DPD Project # 3009397 | Design Guidance

Medical Dental Building, 2800 MLK Jr Way S., Seattle, WA

Design Guidance Response

Landscape Site Plan & Green Factor

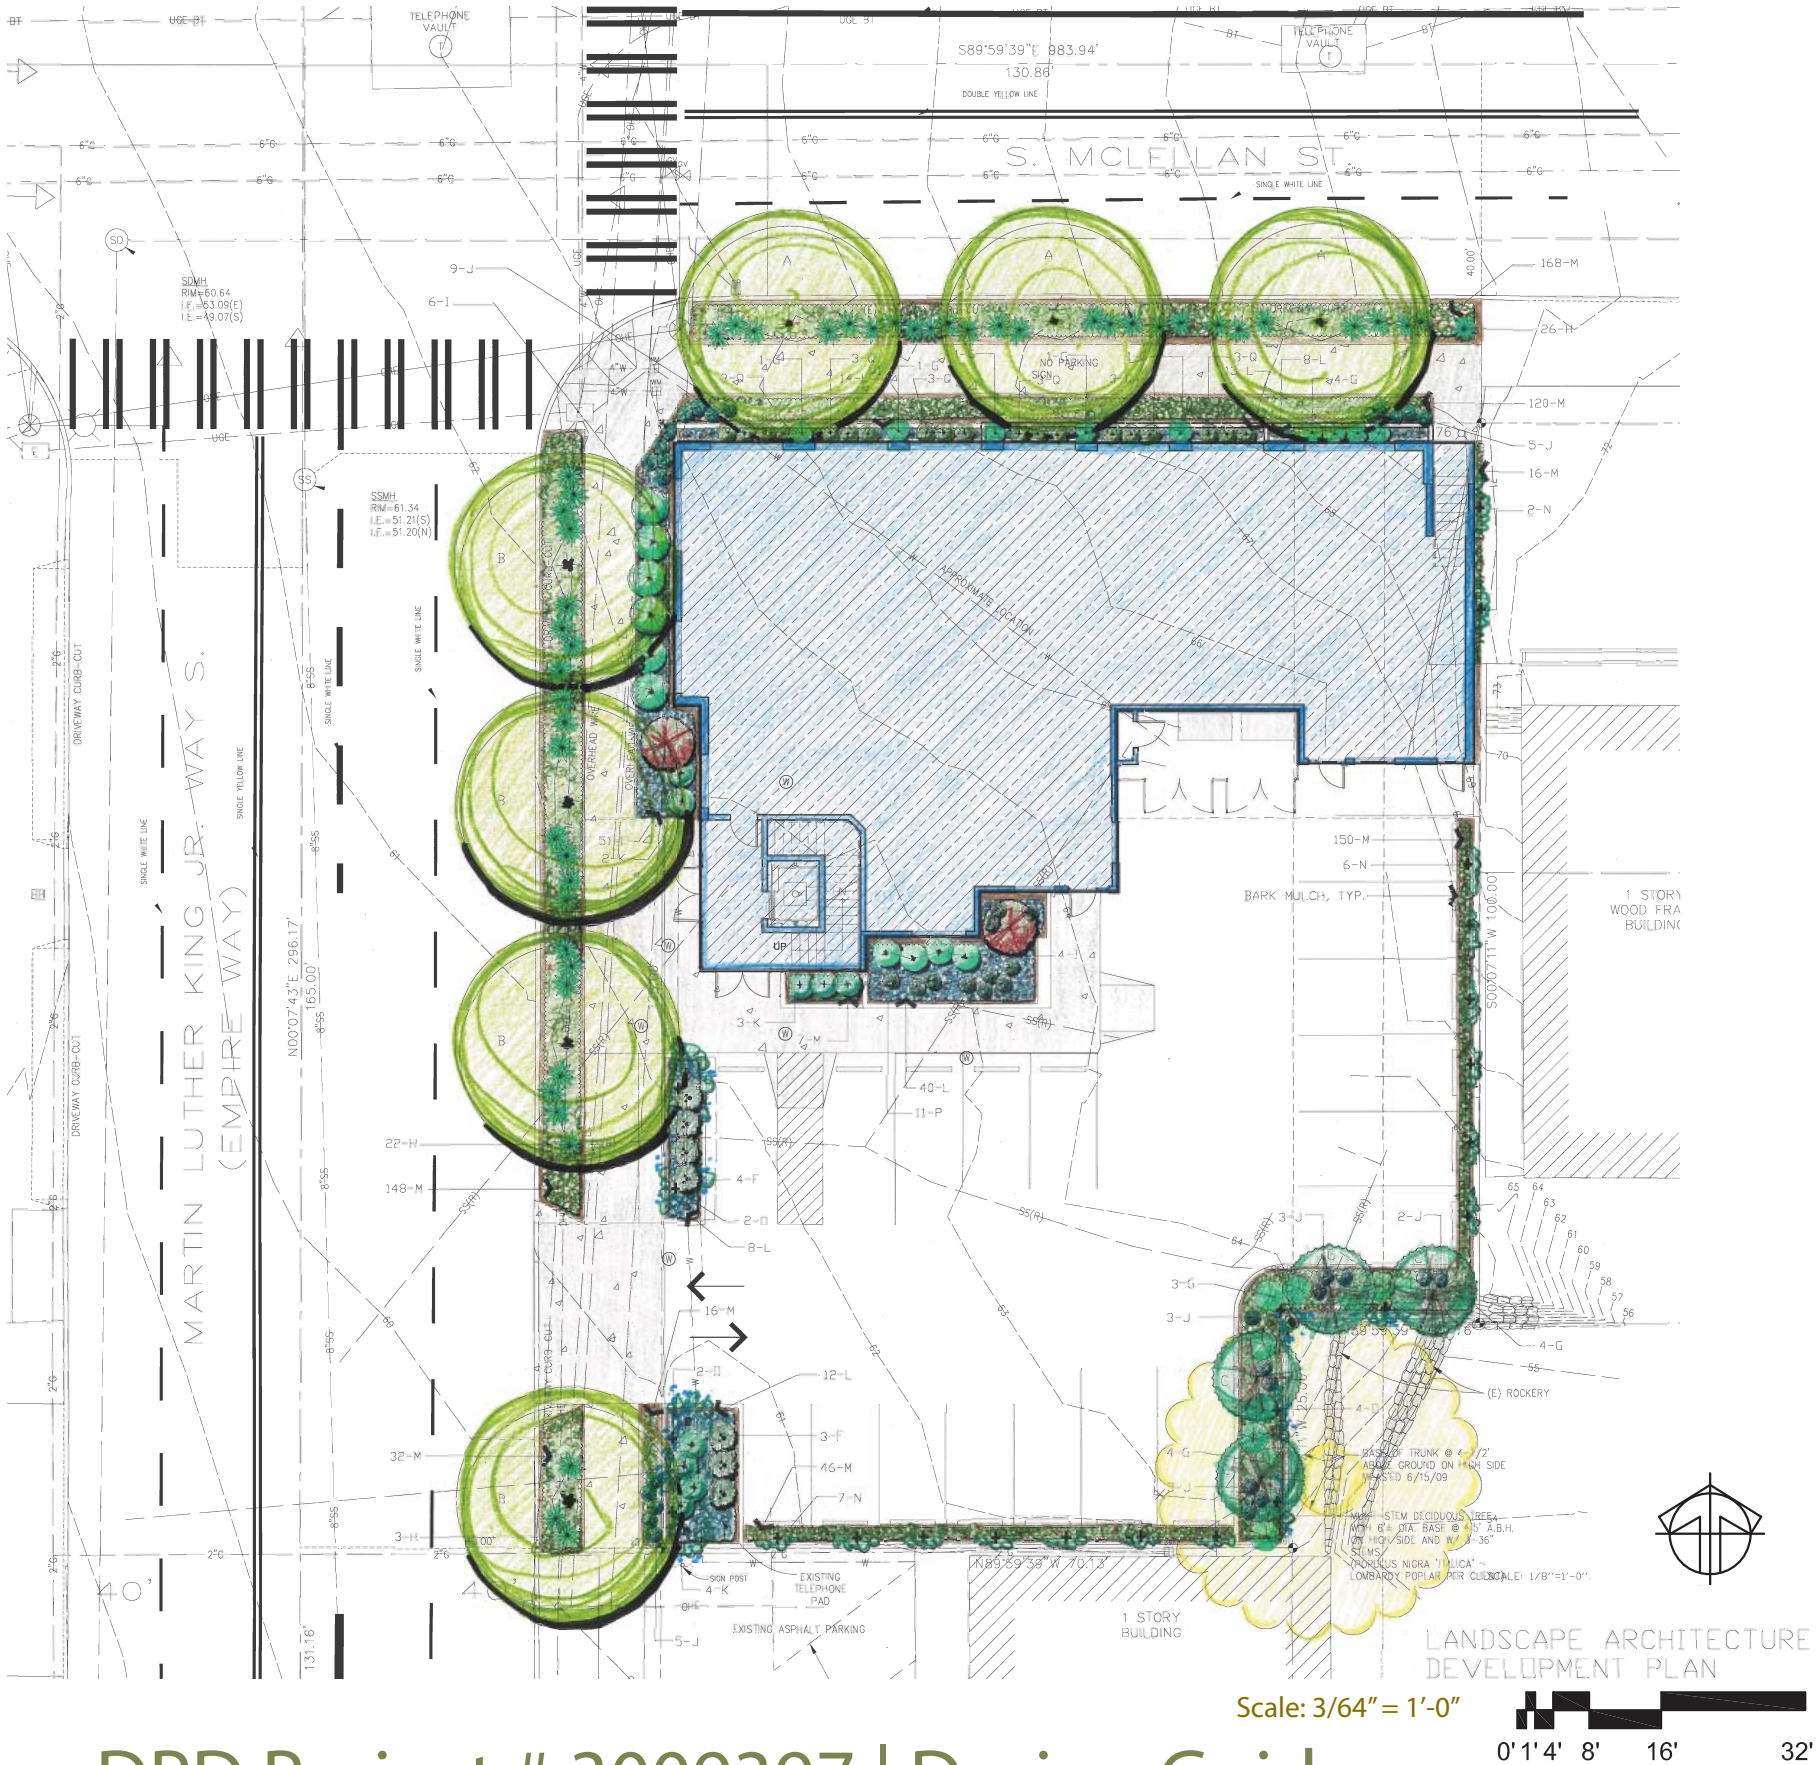
E-2 Landscaping to Enhance the Building and/or Site.

- See comments under A-1 and A-8/A-9. To reduce stormwater runoff, pervious asphalt paving material will be used on the new parking area. See Green Factor Score Sheet on sheet 5.

Architectural Site Plan & Project Data

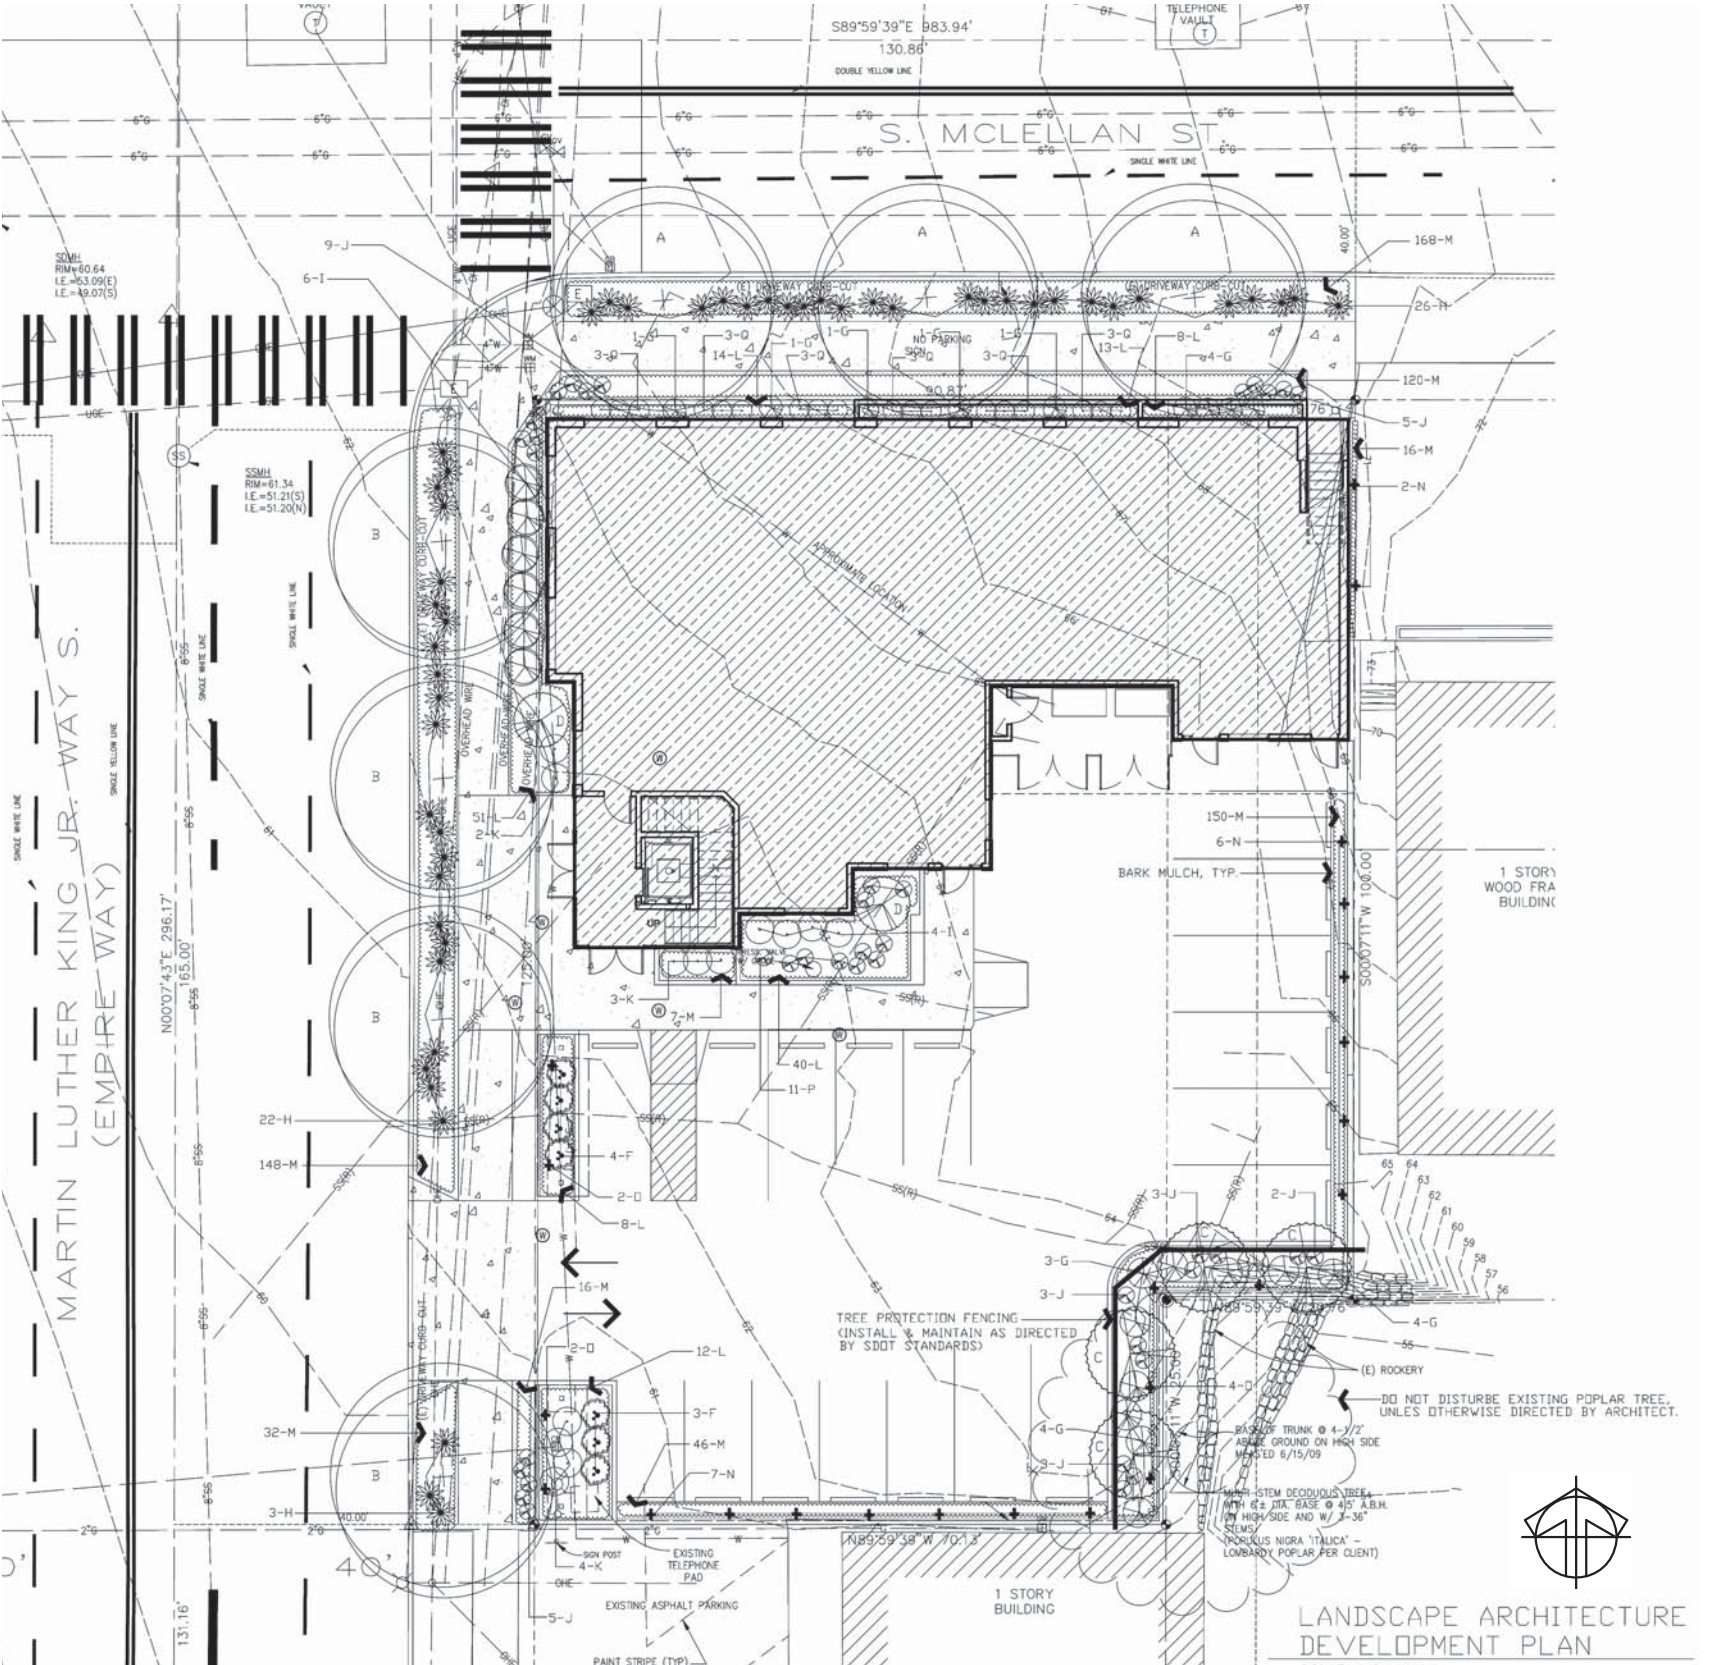
- Full required transparency must be included in at least the first 30-feet from the corner of the McClellan façade.
- Landscaping along the southeast corner of the proposed parking area should adequately and attractively screen this area from the single-family properties to the southeast.
RAI Response:

- SDOT Preliminary Approval required for portion of planters and proposed cistern in the right of way.
- Minimizing the visibility of the parking lot from MLK is a priority for this Design Departure. The proposed 24 foot driveway does not work toward that goal. An 18-20 foot width should be explored and presented as an alternative. Narrowing the interior drive aisle should also be explored. This could be approved through a Design Departure.
RAI Response:

- The cistern and portion of planter structures beyond property line have been omitted per SDOT requirements.
- The 24' driveway has been reduced to 20' wide driveway as requested under proposed design departure. See sheet 7 for layout and dimensions.

- Transparency for the first 30' of S. McClellan façade has been met and calculation provided in sheet 7, 8, and 12.
The 6' deep planter has been reduced to 2' deep planter to meet SDOT requirement of no encroachment into the right of way, and the height of the planter is reduced to less than 2' high. This would ensure the ground cover plants proposed for the planter area will not block transparency. Please refer to sheet 17 for sectional detail through one of the planters along S. McClellan façade to see how the proposed design meets the transparency requirement.

North Elevation (S. McClellan)

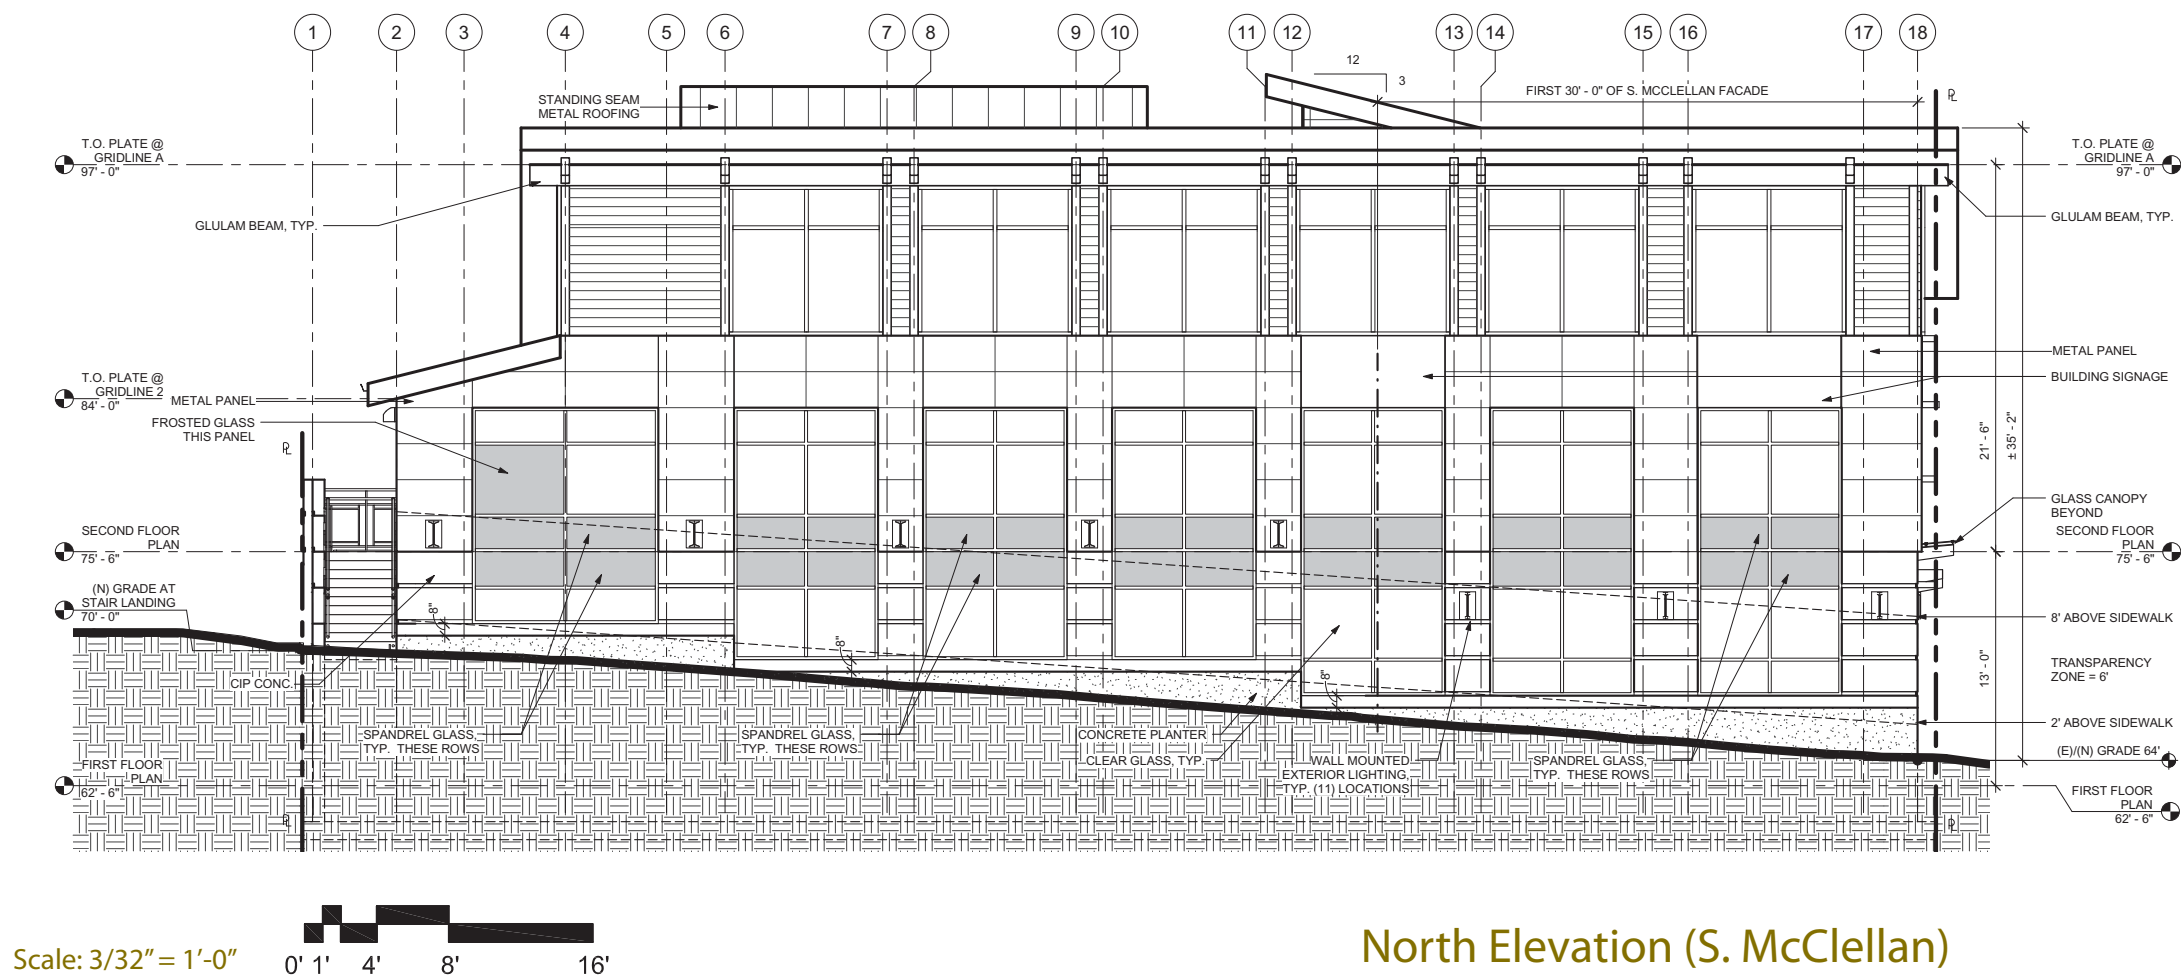
- The Code required glazing along the western 30-feet of McClellan Street and MLK Way should not use frosted glass or similar at the corner.

- The proposed design meets the required 30' of transparency along McClellan facade. See sheet 12.
- Beyond the 30' requirement, sandblasted art glass maybe used for privacy into the treatment rooms.
